# Access Compliance Report

## Public Rights-of-Way

Intersection ID: 10038266	Main Street: SMITHFIELD_CHURCH_RD	Cross Street: N/A	Location: SE
ADA ID: 5BAB7CF6B0BF	Ramp Type: PerpDiag	Initial Pass/Fail: Fail	Overall Compliance: No
Codes/Mitigation Info/Possible Solution		Field Measurements/Component Compliance

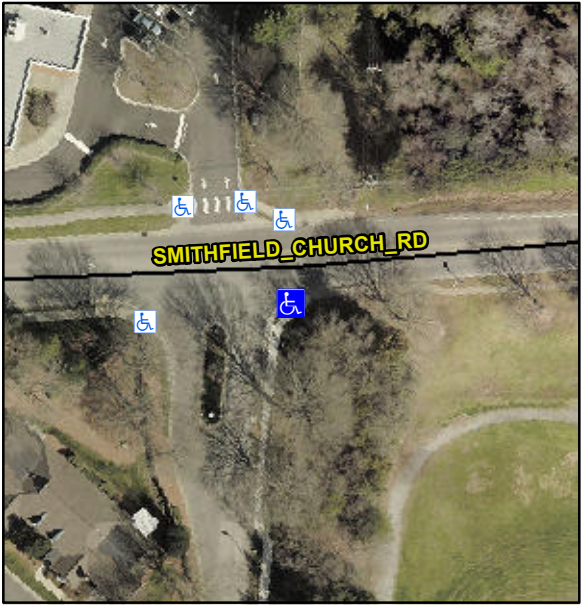
Possible Solutions:	Compliance	Description	Data	Compliance	Description	Data
	Remove & Replace Curb Ramp With Two New Directional Ramps or Equivalent.	N/A	Ramp Length (in)	48.0	Yes	Ramp Slope (%)	5.8
<p>Surveyor Notes:</p> <p>N/A</p> <p>PROW/ADA:</p> <p>Not Found, R304.5.1, R304.5.3</p>		No	Ramp Width (in)	43.5	No	Ramp XSlope (%)	2.4
		N/A	Flare Type LT	N/A	N/A	Flare Type RT	N/A
		N/A	Flare Slope LT (%)	N/A	N/A	Flare Slope RT (%)	N/A
		N/A	Flare Traversable LT?	N/A	N/A	Flare Traversable RT?	N/A
		N/A	Landing Length (in)	N/A	N/A	DWS Provided?	N/A
		N/A	Landing Width (in)	N/A	N/A	DWS Contrast?	N/A
		N/A	Landing Slope (%)	N/A	N/A	DWS Length (in)	N/A
		N/A	Landing X Slope (%)	N/A	N/A	DWS Full Width?	N/A
		N/A	Landing Curb? (Y/N)	N/A	N/A	DWS Offset (in)	N/A
		N/A	Shared Landing?	N/A			
		N/A	Gutter Ponding?	N/A	N/A	Gutter Slope (%)	N/A
		N/A	Gutter Lip Ht (in)	N/A	N/A	Gutter X Slope (%)	N/A
		N/A	Painted X Walk1?	No	N/A	Painted X Walk2?	No

X Walk 1 Direction	To N		X Walk 2 Direction	To W
		N/A	X Walk 1 Width (in)	N/A	N/A	X Walk 2 Width (in)	N/A
			X Walk 1 Slope (%)	8.1		X Walk 2 Slope (%)	0.9
			X Walk 1 X Slope (%)	0.5		X Walk 2 X Slope (%)	3.4
		N/A	Ramp inside XWalk1?	N/A	N/A	Ramp inside XWalk2?	N/A
			Road Slope (%)	1.1	N/A	Clear Space?	N/A
			Road X Slope (%)	5.5	N/A	Clear Space to XWalk (in)	N/A
		N/A	Any Obstructions?	N/A	N/A	Storm Grate/Utility Hazard?	N/A
			Obstruction Type			Storm Grate/Utility Type	
				N/A			N/A
					Yes	Surface Condition? (G/P)	Good
